HISTORIC AND DESIGN REVIEW COMMISSION

HDRC CASE NO: 2022-051
ADDRESS: 419 N MONUMENTAL
LEGAL DESCRIPTION: NCB 1373 BLK 1 LOT 33
ZONING: H
CITY COUNCIL DIST.: 2
DISTRICT: Dignowity Hill Historic District
APPLICANT: Manuel Almar/Manuel Almar
OWNER: Manuel Almar/Manuel Almar
TYPE OF WORK: Exterior modifications, construction of a rear addition, fenestration modifications, porch modifications, window replacement, fencing
APPLICATION RECEIVED: February 18, 2022
60-DAY REVIEW: Not applicable due to City Council Emergency Orders
CASE MANAGER: Edward Hall
REQUEST:

Historic and Design Review Commission
Design Review Committee Report

REAR ELEVATION

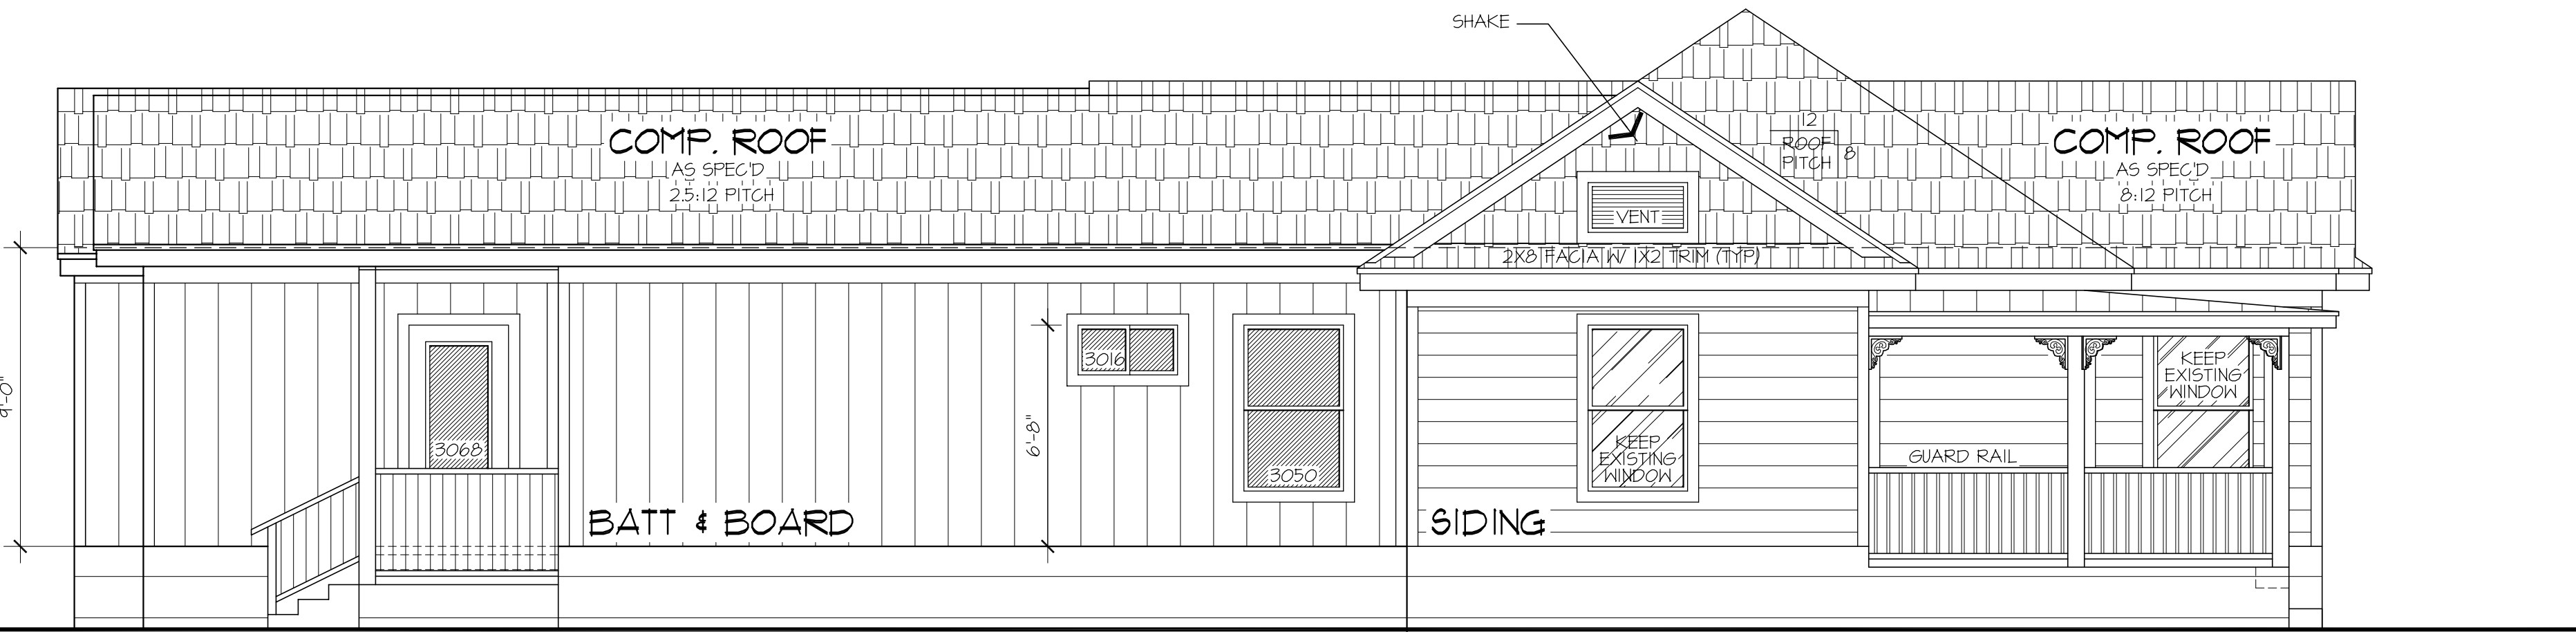
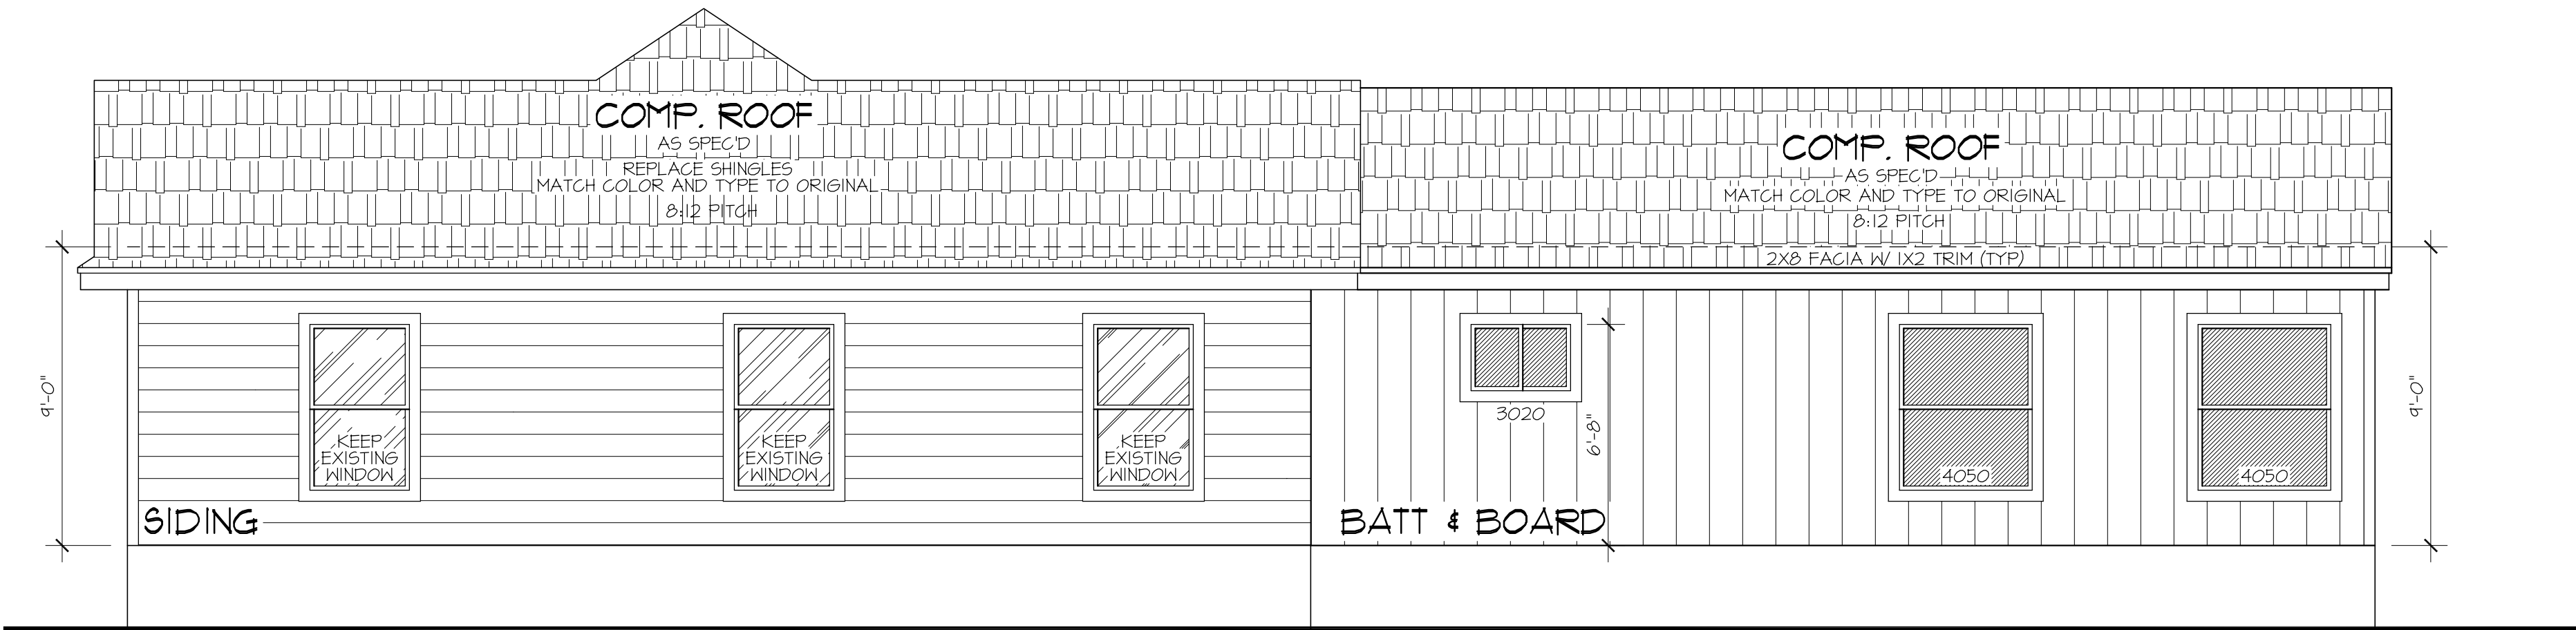
- n. ROOF FORM – The applicant has proposed for the rear addition to feature a rear gabled roof with an uncentered ridge line resulting in a long, low slopes profile to the south. The Guidelines for Additions 2.A.iii., roof forms should utilize similar roof pitch, form, and orientation as the principal structure for additions, particularly for those that are visible from the public right-of-way. Staff finds the proposed roof form of the addition to be inconsistent with the Guidelines.

- o. ARCHITECTURAL DETAILS – As noted in finding m, staff finds that the proposed addition should feature a roof form that is consistent with the Guidelines. Additionally, staff finds that all window openings should be consistent with the Guidelines, and that contemporarily sized windows should be eliminated for traditionally sized windows.

MS: The general updates seem to work on paper; however, the asymmetrical gable/shed portion looks a bit odd.

- iii. That the applicant modify the proposed roof form to feature a rear gable that features a centered ridge line to result in a gable with equal slopes of both sides.

- iv. That the rear addition feature traditionally sized windows with a one over one profile and that all rectangular windows be modified to feature traditional sized. Large, picture windows should be modified to feature openings that are consistent with the historic structure's original openings.
